Device TC29x
Marking/Step ES-BC, BC
Package see Data Sheet

No. 030/19

This Errata Sheet describes the deviations from the current user documentation.

Figure 1 Message buffer transfer from Message RAM to OBF

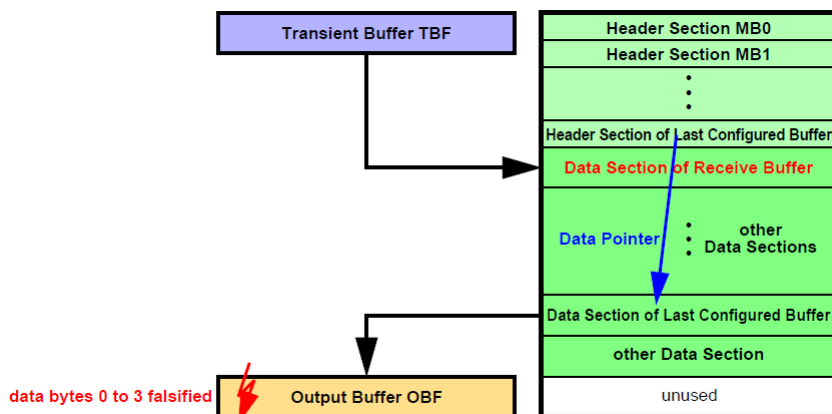
a) When a message is transferred from the Last Configured Buffer in the Message RAM to the OBF and **PLC** = 127 it may happen, that at the end of the transfer the OBF word on address 00h (payload data bytes 0 to 3) is overwritten with unexpected data (see [Figure 1](#)).

Figure 2 Message buffer transfer from IBF to Message RAM

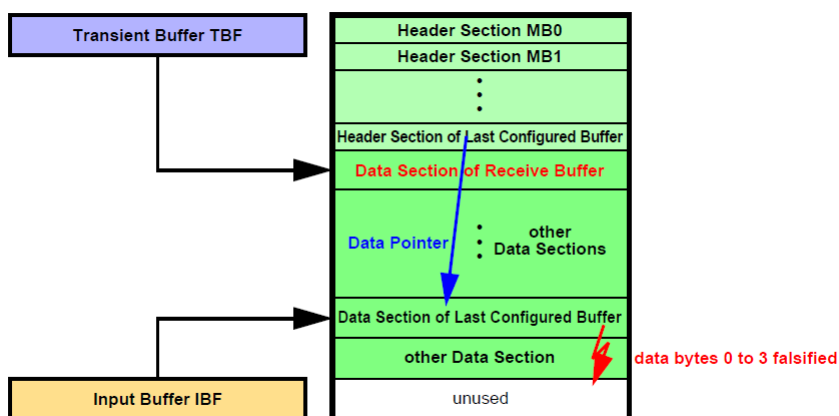
b) When a message is transferred from IBF to the Last Configured Buffer in the Message RAM, it may happen, that at the end of the transfer of the Data Section one additional write access overwrites the following word, which may be the first word of another message's Data Section in the Message RAM (see [Figure 2](#)).

Figure 3 Message RAM Configurations

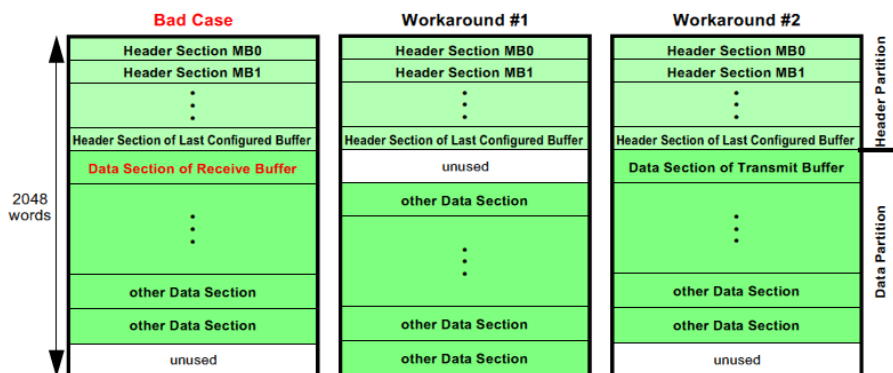
The erratum is limited to the case when (see [Figure 3](#) “Bad Case”):

2) Ensure that the Data Section directly following the Header Partition is assigned to a transmit buffer.

Table 56 Register PMSWSTAT - Bits 19:16

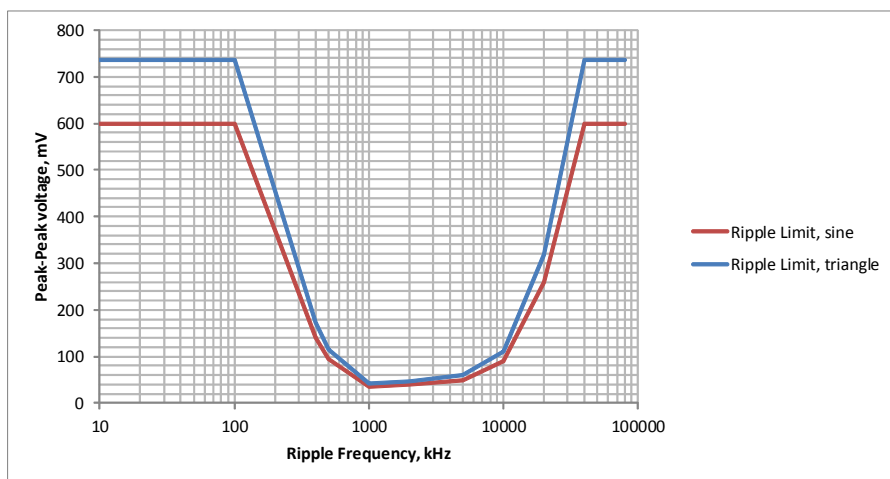
In the description of the Standby and Wake-up Status Flag Register (PMSWSTAT) in the User’s Manual, bit PMSWSTAT.16 is erroneously shown as 0_B.

As the reset value of PMSWSTAT.16 = 1_B, the correct description of bit 16 in PMSWSTAT is as shown in [Table 56](#) below:

Field	Bits	Type	Description
Res	16	r	Reserved Read as 1
0	19:17	r	Reserved Read as 0

Figure 13 SENT Tolerance of this Design Step

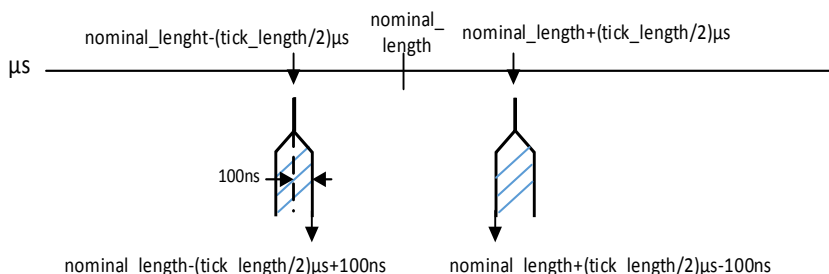
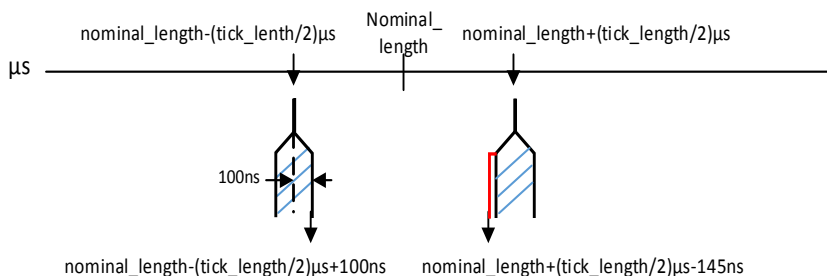
In this design step the range is delimited as follows:

- The lower border is $\text{nominal_value} - (\text{tick_length}/2) \mu\text{s} + 100 \text{ ns}$
- The upper border is $\text{nominal_value} + (\text{tick_length}/2) \mu\text{s} - 145 \text{ ns}$.
